Before the Independent Hearings Panel
At Christchurch City Council

Under the	Resource Management Act 1991 (RMA or Act)
In the matter of	proposed private plan change 23 (PC 23) to the Christchurch District Plan
And	LMM Investments 2012
	Applicant

Joint Witness Statement for Urban Design and Landscape

18 May 2026

PROPOSED OUTLINE DEVELOPMENT PLAN (1:7,500 @A3)

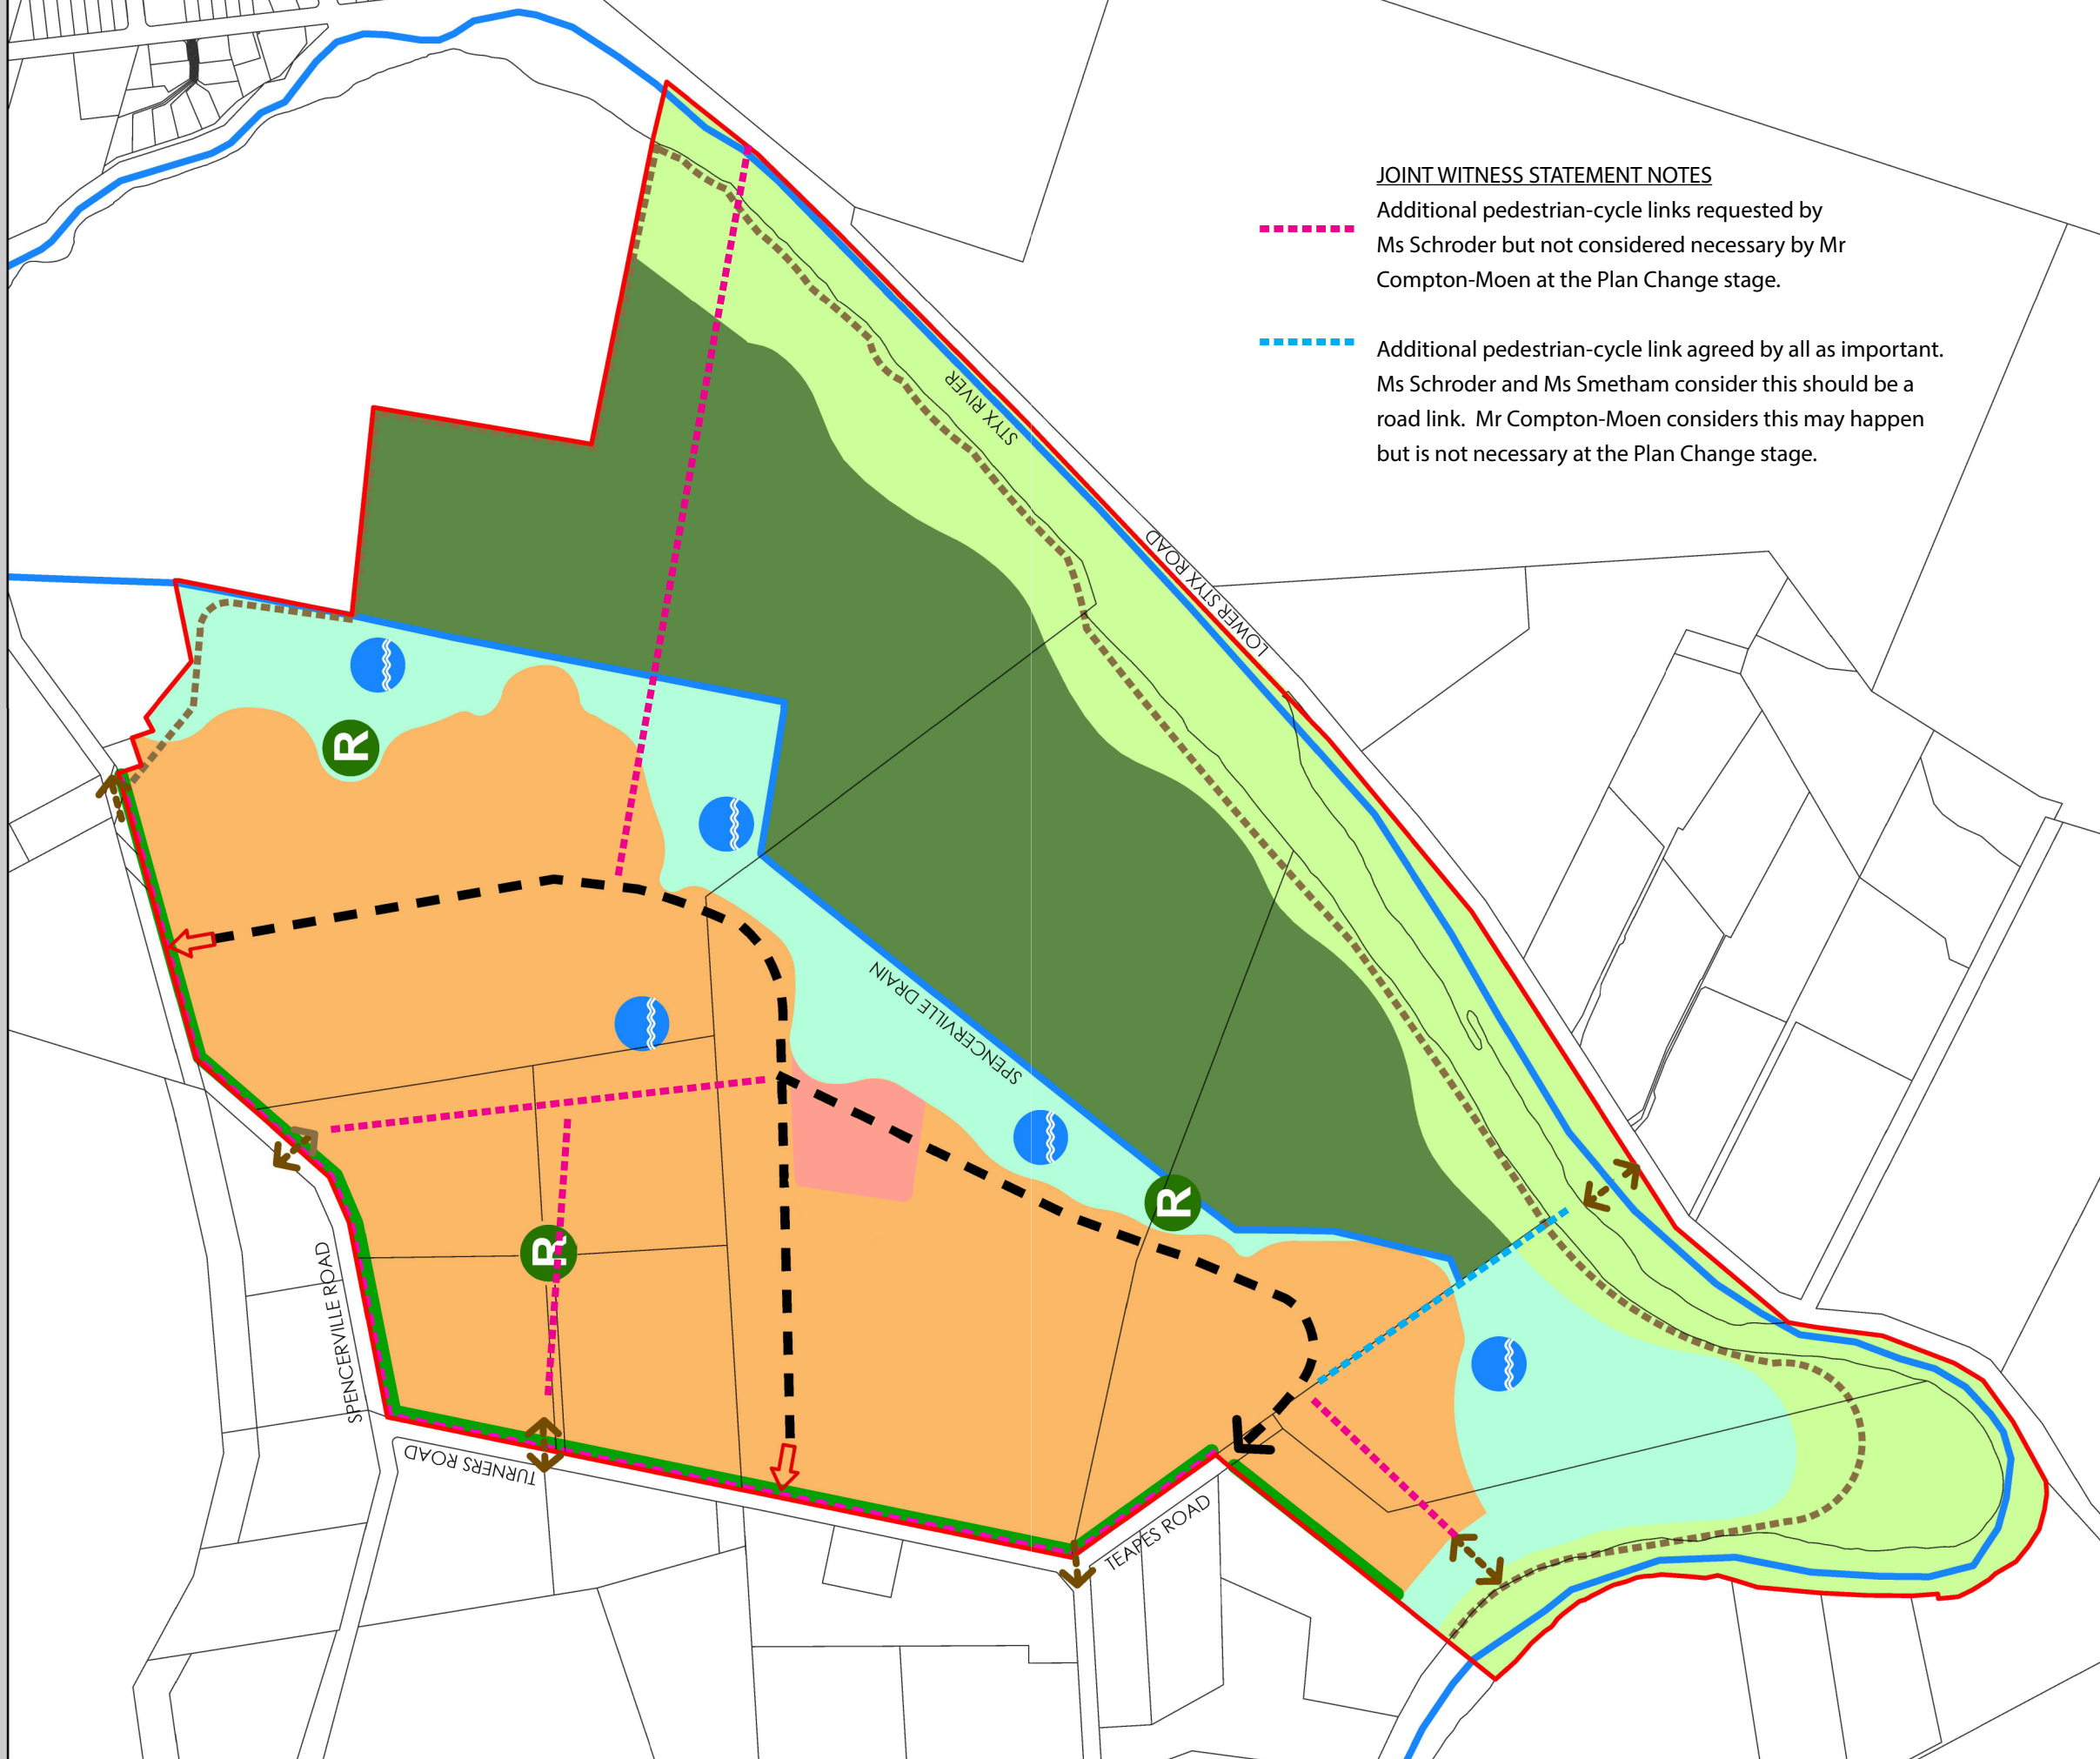
- 20 All agree that the additional pedestrian/cycle connection points indicated at the edges of the ODP are positive. However, Ms Schröder and Ms Smetham consider that the primary (key) pedestrian and cycle routes, like collector roads, should be identified on the ODP with particular emphasis on connections to the existing bridge adjacent to Lower Styx Road and to the village centre. Mr Compton-Moen agrees that these are necessary but just as ODP's only show collector roads and not smaller roads or all links, future links will occur once the scheme plan is further developed, i.e. at subdivision stage.

- 21 Ms Schröder, Ms Smetham and Mr Compton-Moen agree that there should be an indicative pedestrian/cycle link between Teapes Road and the Lower Styx Road bridge. Ms Schröder and Ms Smetham consider that this route should also be further investigated for a future indicative road link. Mr Compton-Moen does not agree and considers that a pedestrian /cycle connection is sufficient.

- 24 Ms Schröder considers that the direct connection between the village centre to Spencerville is an important future connection to retain for direct access and should be illustrated on the ODP as such to ensure the opportunity is not lost through time. Mr Compton-Moen notes that a network of connections has been provided on the ODP and on other maps to show how connectivity and accessibility can and will be achieved. The ones shown are not the maximum and other paths will be developed over time, noting that any subdivision consent still needs to go through a consenting process.

- Additional pedestrian-cycle links requested by Ms Schroder but not considered necessary by Mr Compton-Moen at the Plan Change stage.
- Additional pedestrian-cycle link agreed by all as important. Ms Schroder and Ms Smetham consider this should be a road link. Mr Compton-Moen considers this may happen but is not necessary at the Plan Change stage.
